Technical Bulletin 192

07.2018

Contents

Item: 192.1
Description: Lower Chain Guard
Model Affected: Tiger Sport

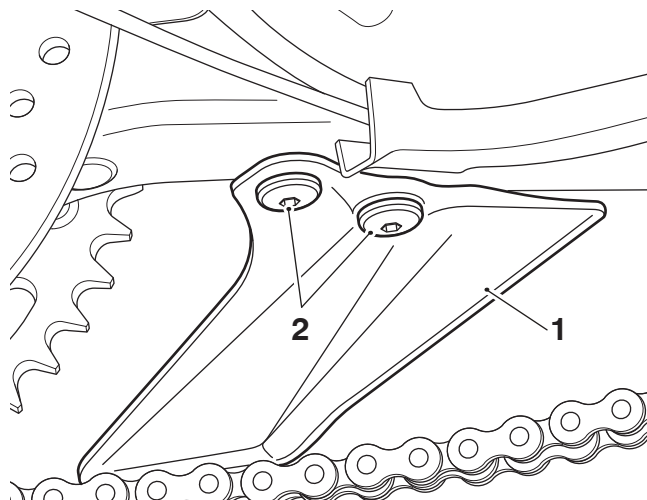
New lower chain guard fixings with a decreased torque have been introduced to the above models from VIN 900639. The fixings are retrofittable.

The torque figure has changed. If loosened or removed for any reason the encapsulated fixing(s) must be replaced.

Tighten the fixings to **5 Nm**.

Item: 192.3

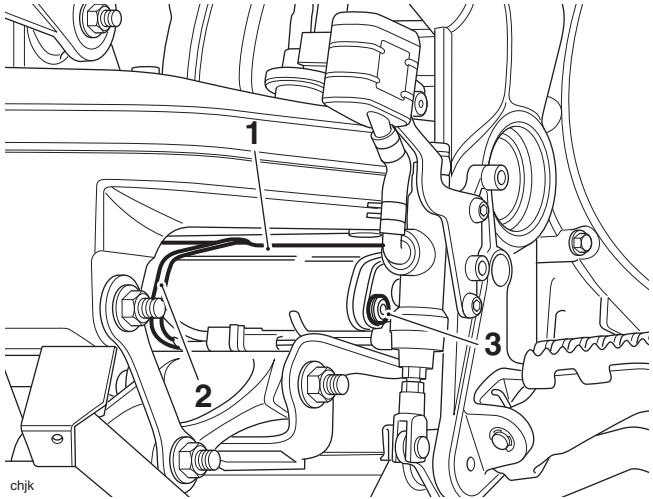
The torque figure of the evaporative canister fixing on the above models has been decreased.
The torque figure has changed for the fixing(s). If loosened or removed for any reason the fixing(s) must be tightened to:

Application	Torque (Nm)	Notes
Evaporative Canister	5 Nm

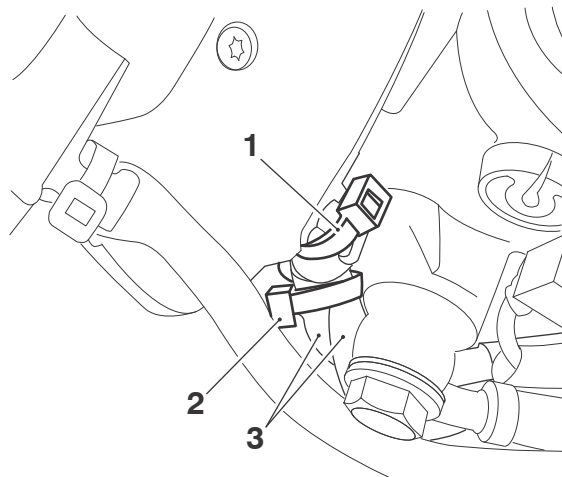
A new clutch assembly has been introduced to the above models from engine number 897378 (all markets except Brazil) and from engine number 897696 (Brazil only) and is retrofittable.

Parts will no longer support the old condition assembly and any replacement will be the new condition.

Old condition clutch assemblies can be updated using the following parts kit:

Item: 192.7

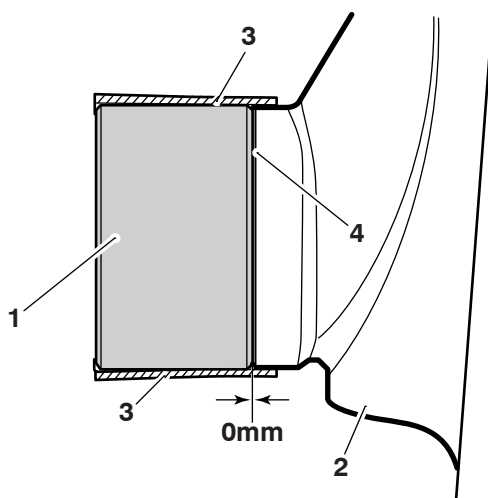
When installing the header pipe to the catalytic converter on the above models make sure the exhaust gasket is fully inserted into the header pipe. Position the exhaust clamp to allow the swaged area of the exhaust header pipe to compress before tightening the fixings as described below.

- Make sure the exhaust gasket is fully inserted against the swaged cup of the exhaust header pipe flange prior to installation.
1. Position the exhaust gasket fully into the exhaust header pipe flange.

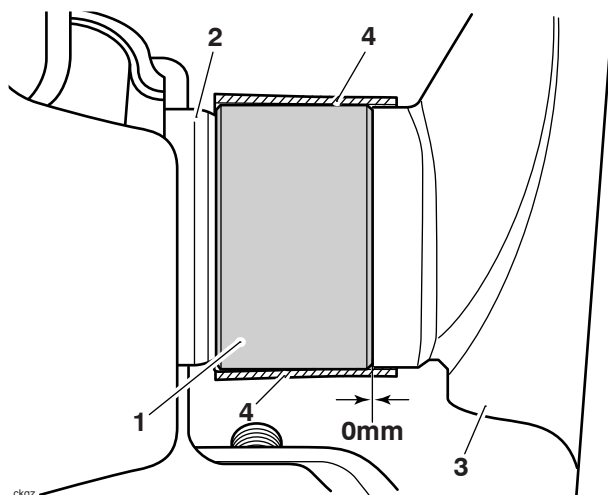
2. Fit the header pipe to the catalytic converter.

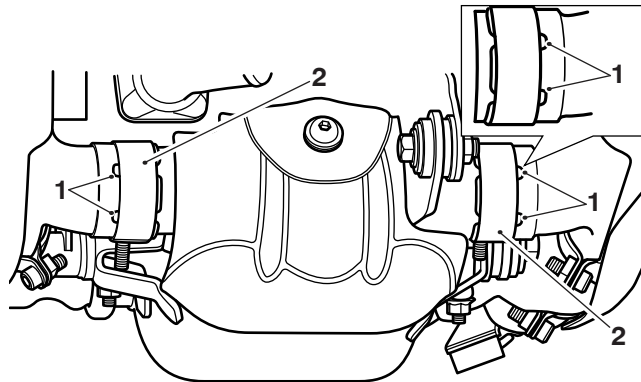
- The compression slots on the exhaust header pipe must be visible to allow correct clamping of the header pipe to the catalytic converter.
3. Position the exhaust clamp to the exhaust header pipe as shown below and tighten the fixing to **10 Nm**.

Pinpoint Tests - Tiger Explorer XR, Tiger Explorer XRX, Tiger Explorer XRX-LRH, Tiger Explorer XRT, Tiger Explorer XC, Tiger Explorer XCX, Tiger Explorer XCX-LRH, Tiger Explorer XCA, Tiger 1200 XR

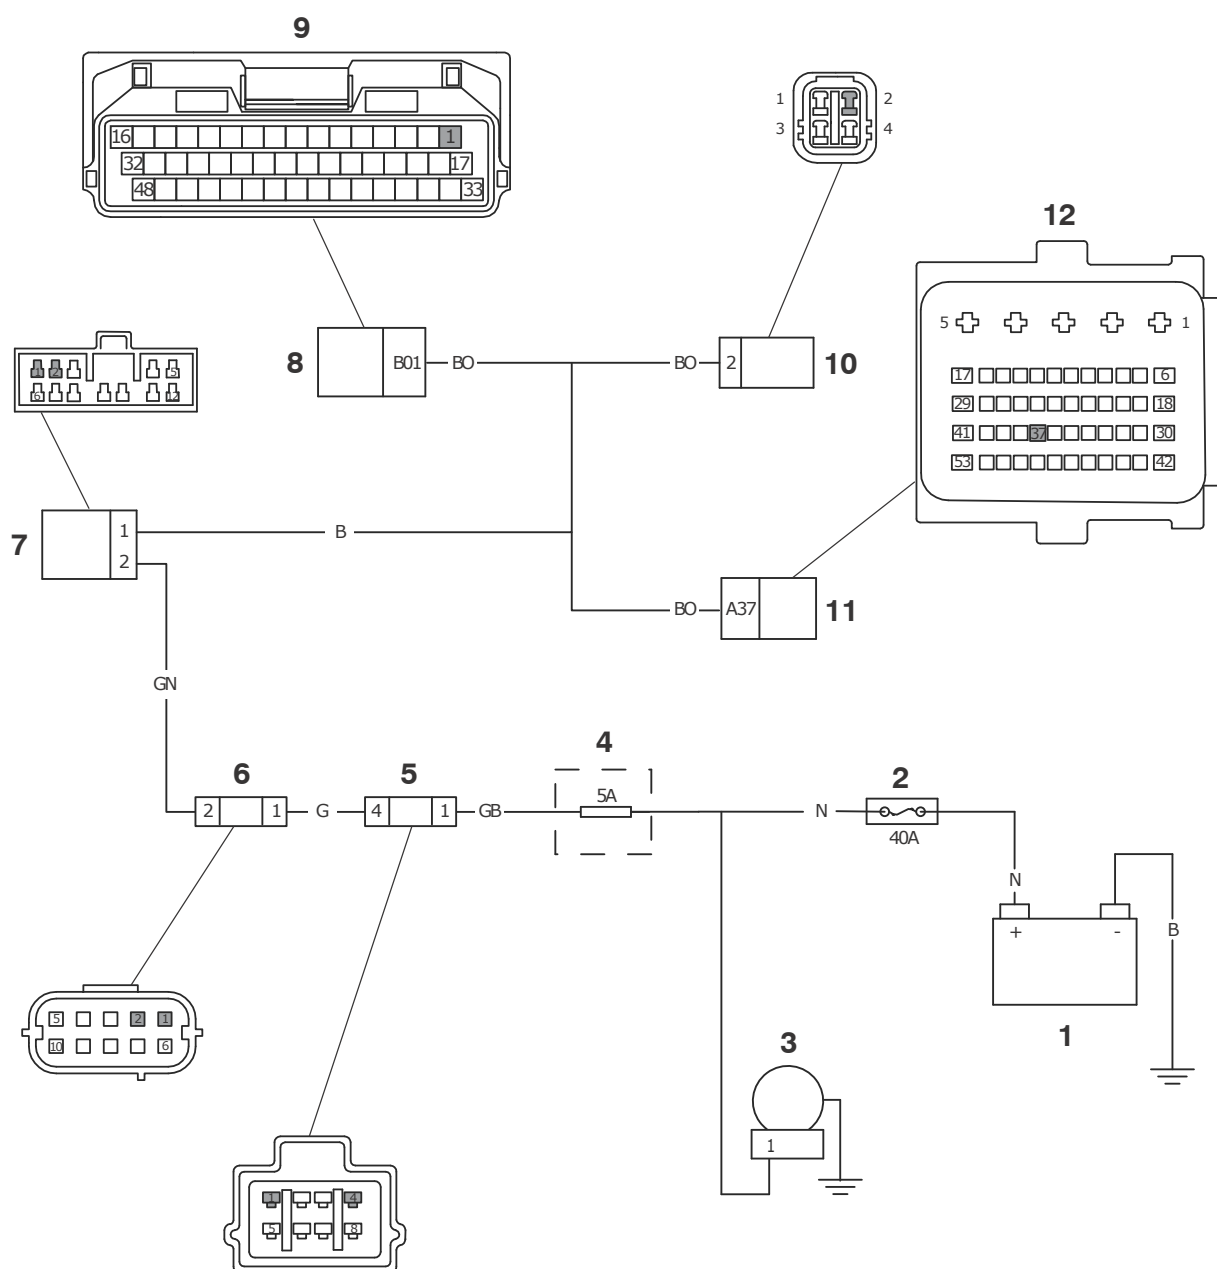
The pinpoint test for Alternator Diagnosis has changed for the above models. This information amends the current Service Manual procedure.

Test	Result	Action
1	Check cable and terminal integrity: - Battery positive (+) terminal - Battery negative (-) terminal - Alternator control connector pin 2 - Alternator output terminal - Crankcase negative (-) terminal	OK
	Faulty	Proceed to test 2 Rectify fault, proceed to test 2
2	Check fuses: - Main fuse 40 A - Fuse No 6, main fuse box	OK
	Faulty	Proceed to test 3 Replace fuse, proceed to test 3
3	Check alternator control Voltage: - Disconnect alternator control connector - Turn ignition ON - Make sure the engine stop switch is in the RUN position - Disarm the alarm if fitted - Make sure the instruments turn on and the gear position is displayed - Measure the Voltage between alternator control pin 2 and battery negative (-) terminal	Same as battery Voltage (12.5 V +/- 0.5 V)
	Faulty	Turn the ignition off, reconnect the alternator control connector. Proceed to test 4 Turn the ignition off, proceed to test 4

4	Disconnect the battery and check cable continuity: - Battery negative (-) cable ring terminal to alternator metal housing (ground) - Battery positive (+) cable ring terminal to alternator output terminal - Alarm connector 1 to Alternator control connector pin 2 - Engine ECM Connector B, pin B01 to Alternator control connector pin 2	OK
	Open circuit	Reconnect the battery leads, positive (red) lead first and proceed to test 5 Locate and rectify wiring fault. Reconnect the battery leads, positive (red) lead first and proceed to test 5
5	Ensure the alternator control connector is plugged and secured. Run the engine. Check the charging Voltage at 2,000 rpm between: - Alternator output terminal and alternator metal housing (ground) - Alternator output terminal and battery negative (-) - Battery positive (+) and battery negative (-)	13 V - 15 V
	Fault still present	Action complete - quit test Proceed to test 6

Test		Result	Action
6	Measure voltage drop in the charging circuit. Run the engine at 2,000 rpm. Turn all loads on (including heated grips, heated seats and fog lights if fitted). Measure the voltage between: - Battery negative (-) cable ring terminal and alternator metal housing (ground) - Battery positive (+) cable ring terminal and alternator output terminal	OK - Voltage drop less than 0.5 V	Contact Triumph service Provide details of results and observations of any test steps that have failed.
		Faulty - Voltage drop greater than 0.5 V

Item: 192.9
Description: Engine Oil and Filter Change
Model Affected: Speed Triple S, Speed Triple RS

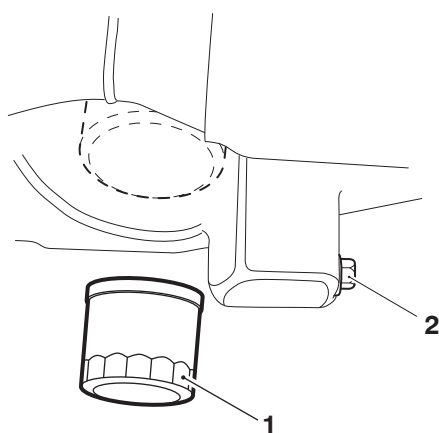
A new procedure for the engine oil and oil filter change has been introduced for the above models. It has come to our attention that a small number of the above models oil pressure warning light did not extinguish after an engine oil and oil filter change. The cause of this is an air lock between the oil pump and oil filter.

To prevent the air lock, dealers should fill the engine with oil before the oil filter is fitted. The revised procedure is described below.

3. Remove the oil drain plug.

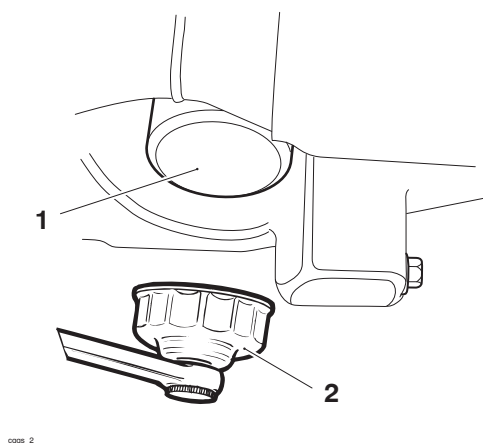
-
5. Unscrew and remove the oil filter using service tool T3880313.

6. Dispose of the old oil filter in an environmentally friendly way.
7. After the oil has completely drained out, fit a new sealing washer to the drain plug. Fit and tighten the plug to 25 Nm.
8. Fill the engine with a 10W/40 or 10W/50 semi or fully synthetic motorcycle engine oil that meets specification API SH (or higher) and JASO MA, such as Castrol Power 1 Racing 4T 10W-40 (fully synthetic) engine oil, sold as Castrol Power RS Racing 4T 10W-40 (fully synthetic) in some countries.
9. Apply a smear of clean engine oil to the sealing ring of the new oil filter.
10. Fit the oil filter and tighten to 10 Nm.
11. Start the engine and allow to idle.
